U.S. ROUTE 40/61 BRIDGE OVER THE MISSOURI RIVER
ST. CHARLES AND ST. LOUIS COUNTIES, MISSOURI
MoDOT JOB NO. J6P1436

FINAL ENVIRONMENTAL IMPACT STATEMENT

Alternatives A1, A2, A2' (2 of 4)
 Plate 14

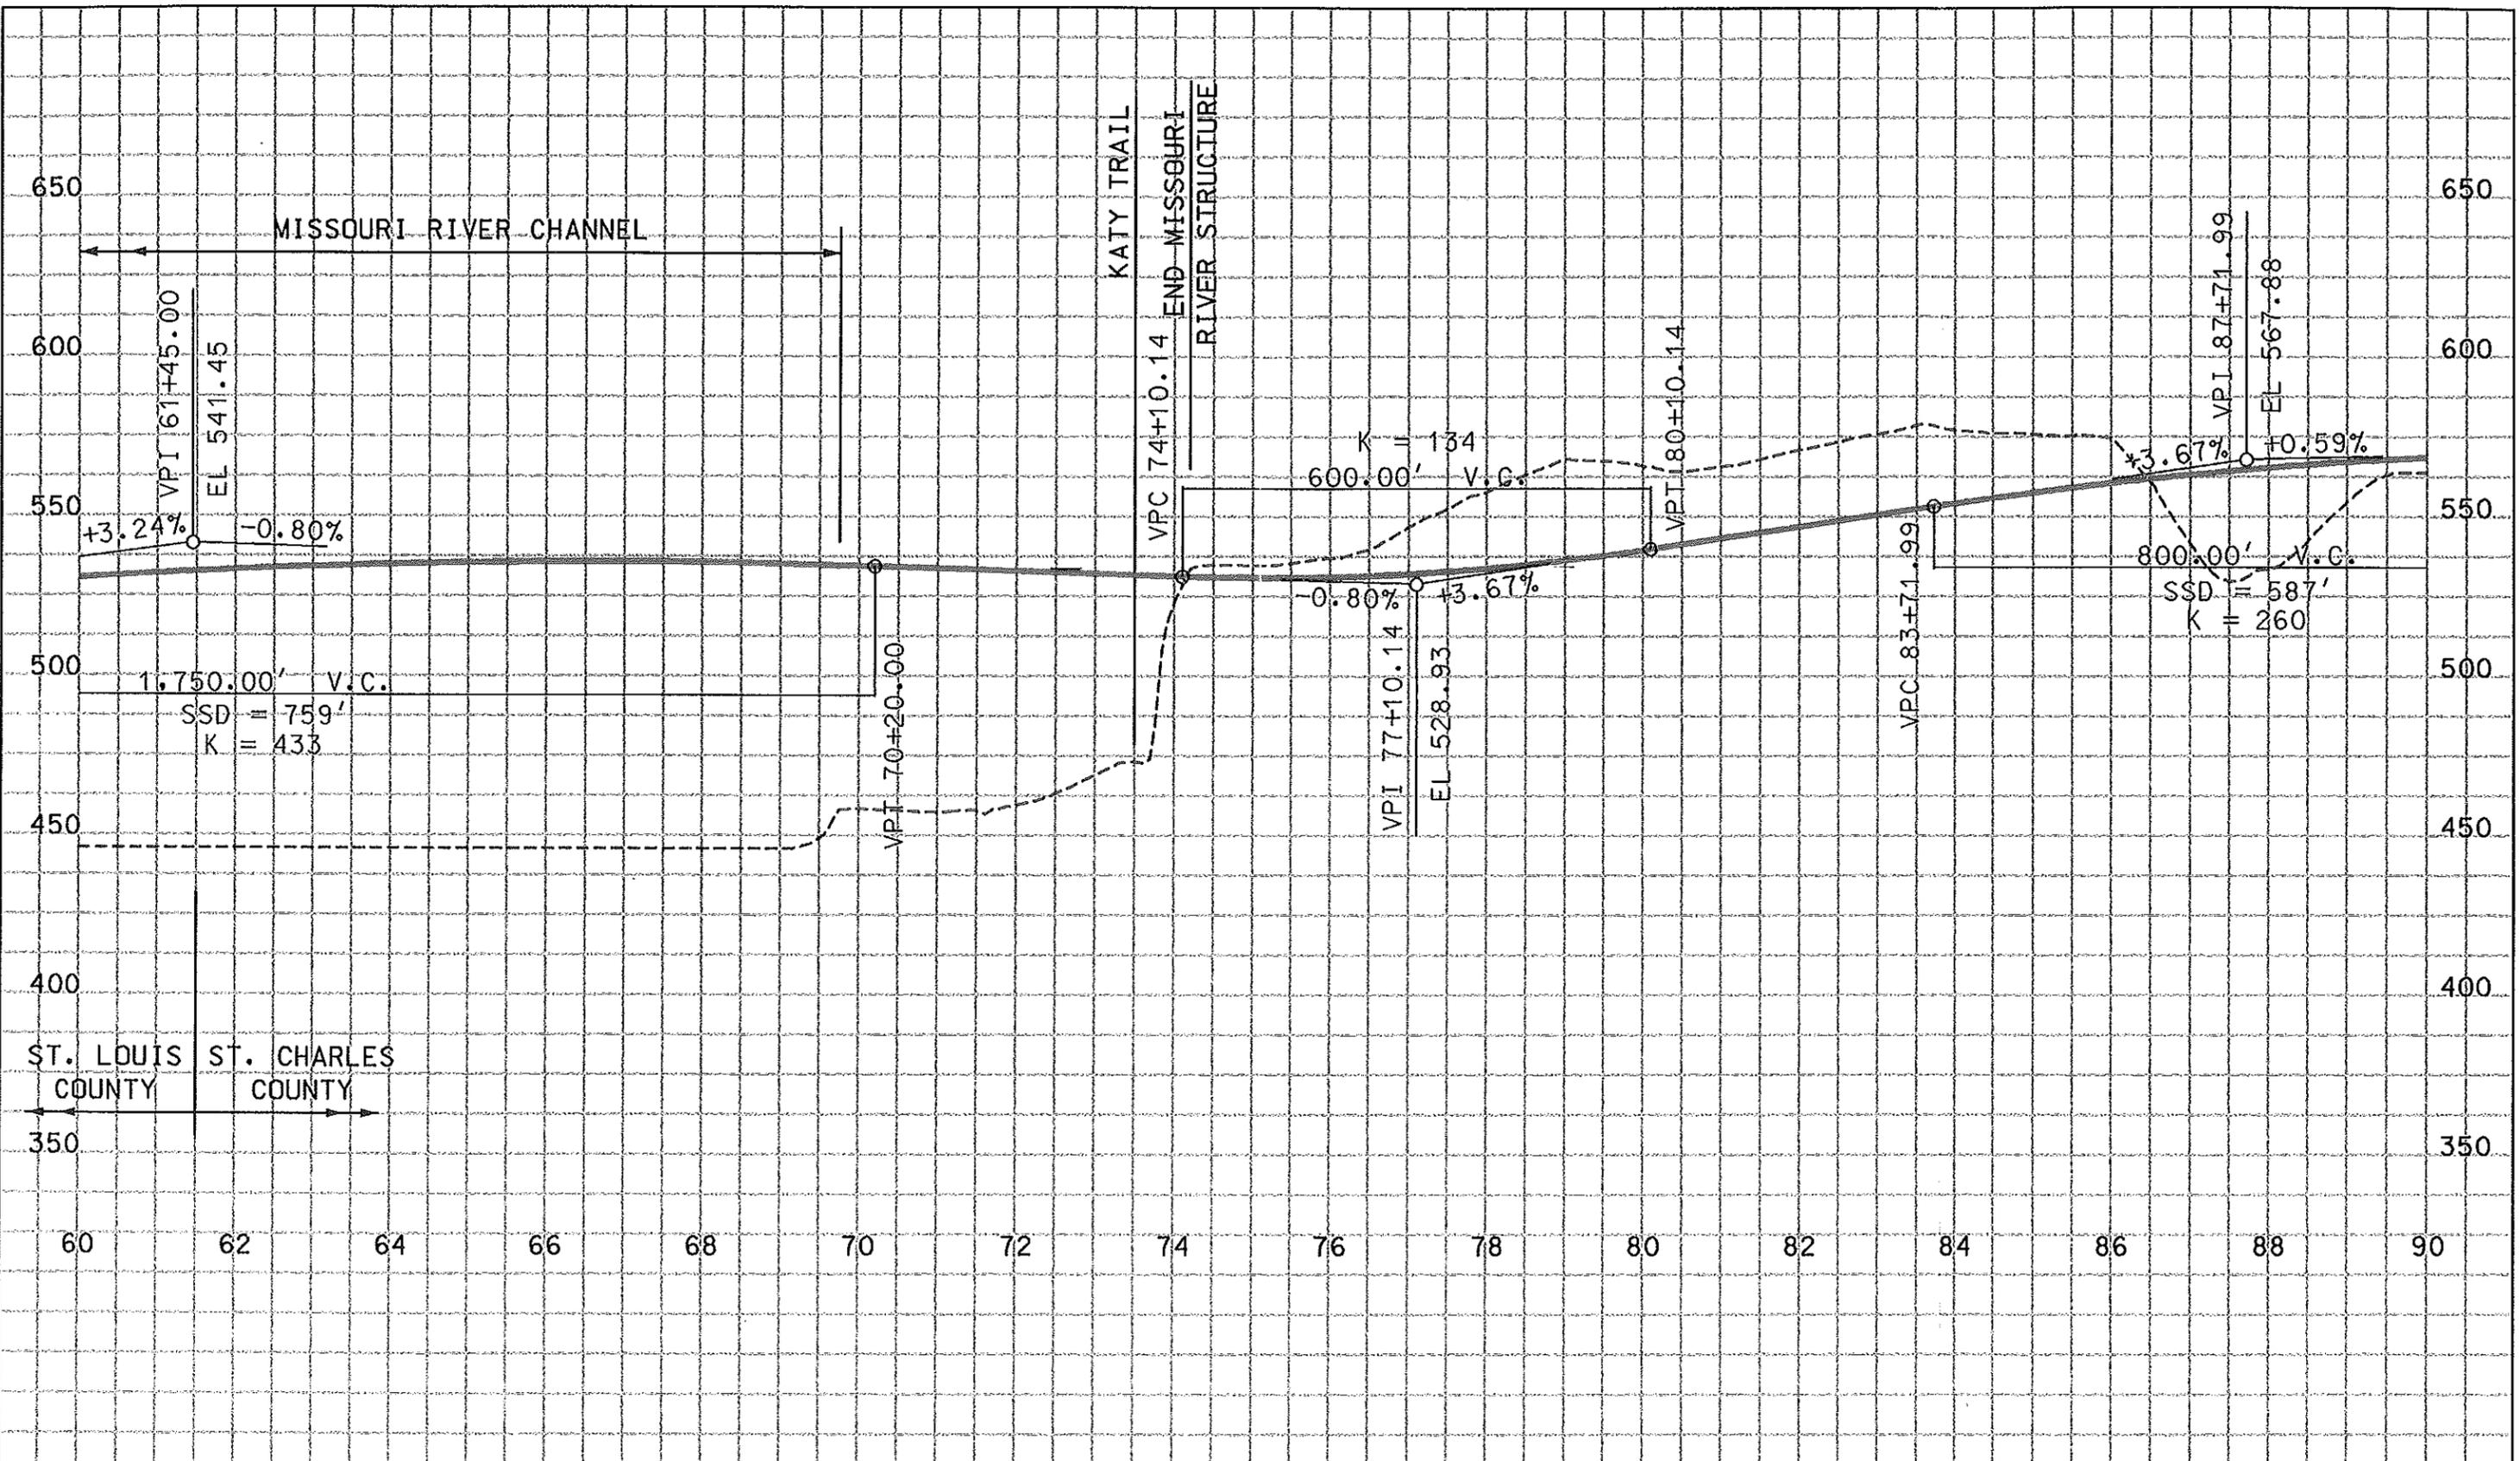
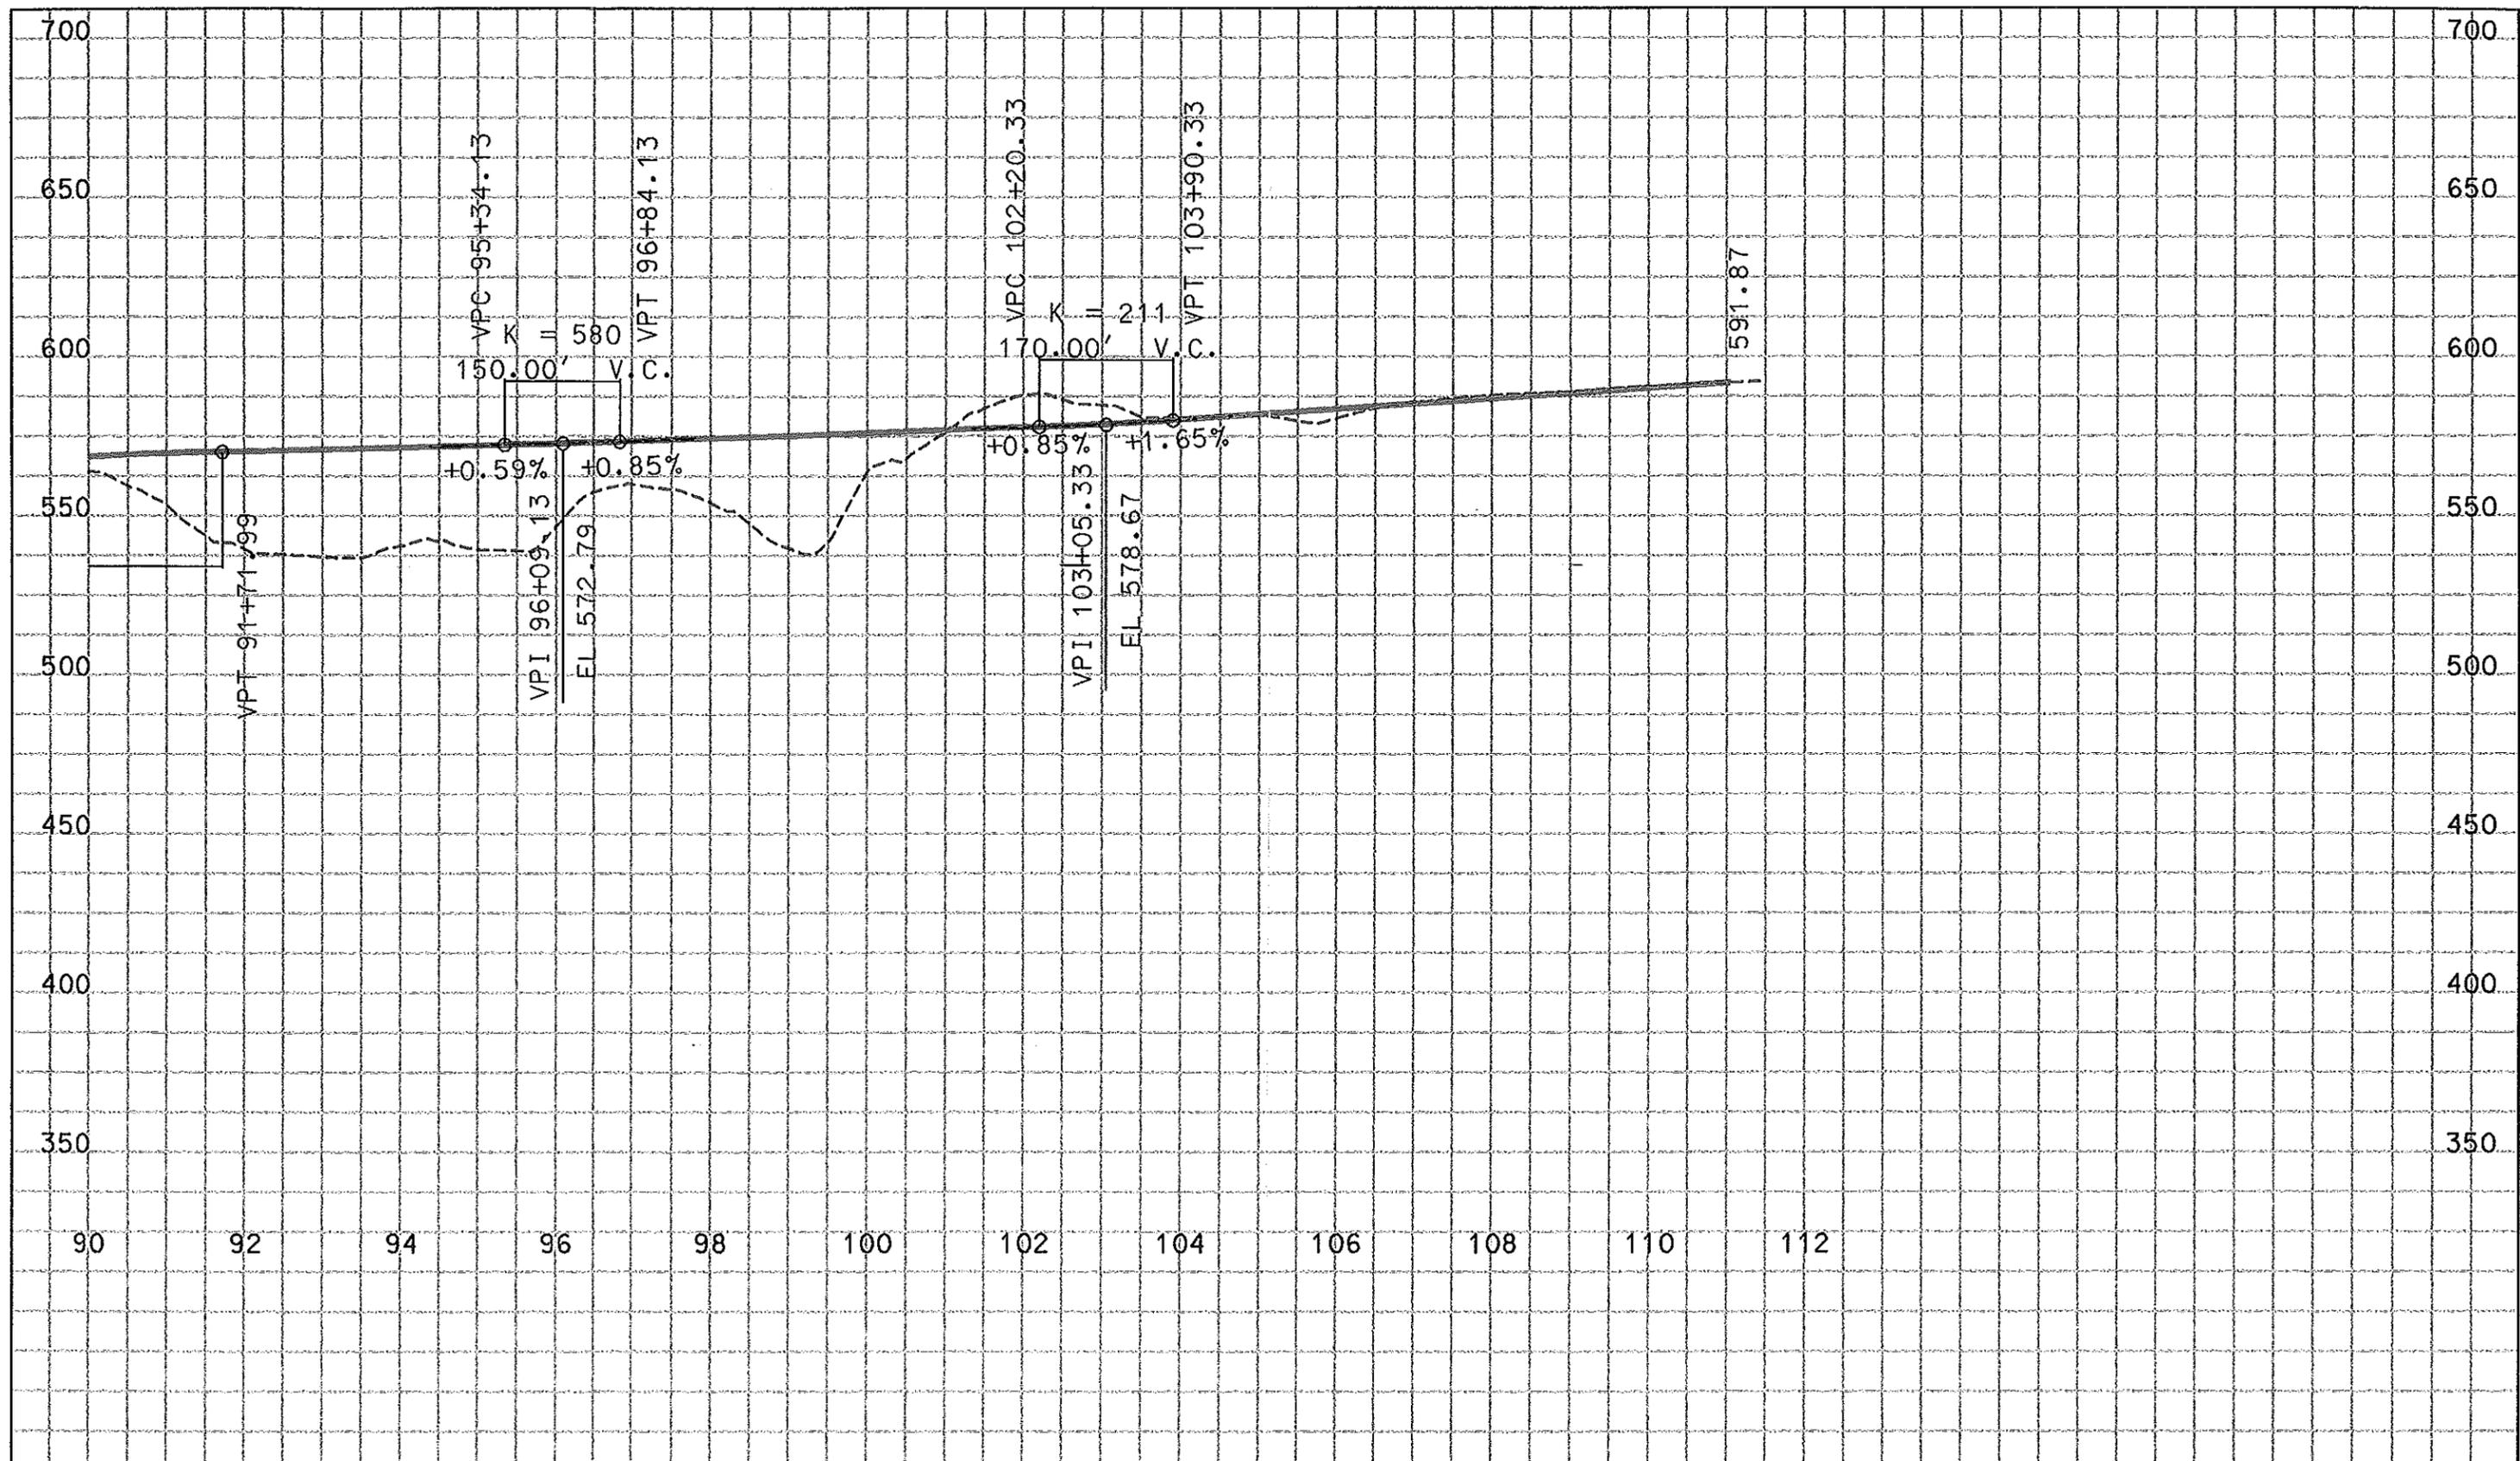
across the existing highway, closing down a vital transportation route. Although Plates 14 & 15 in Appendix E show no new constriction of the river due to the new bridge, and improvements to the Monarch-Chesterfield Levee have been completed, flood heights have been documented as increasing along the Missouri River. Therefore MoDOT may wish to evaluate the roadway elevation at the eastern approach and the possible use of structure to allow water to flow under rather than over the bridge approach. Appropriate design will assure that the approach does not contribute to flooding in this area, and that future inundation of the roadway is unlikely if another disastrous flood such as the Flood of 1993 should occur.
